Access Compliance Report

Public Rights-of-Way

(Curb Ramps)

Intersection ID: 21586	Main Street: FAWNBRook_LN	Cross Street: W_ARROWWOOD_RD	Location: NE
ADA ID: F9C4D8C073BD	Ramp Type: BlendTrans2	Initial Pass/Fail: Pass	Overall Compliance: No
		Severity Score: 2.75

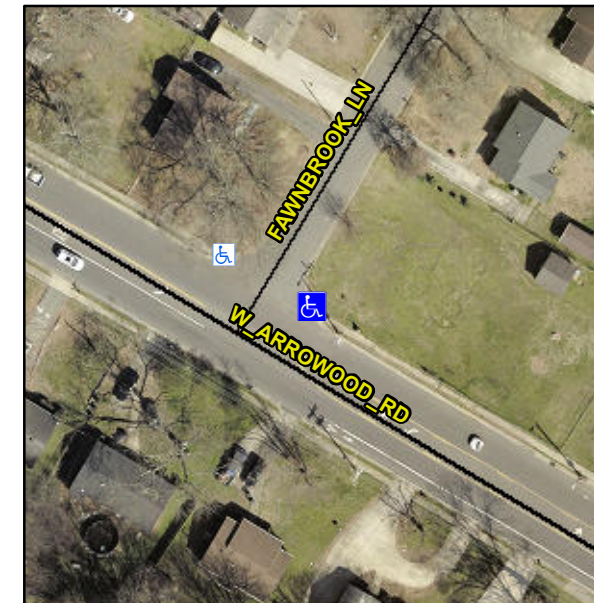
Remove & Replace Curb Ramp With Two New Directional Ramps or Equivalent. Remove & Replace Gutter.

R304.5.3, R305.1.4
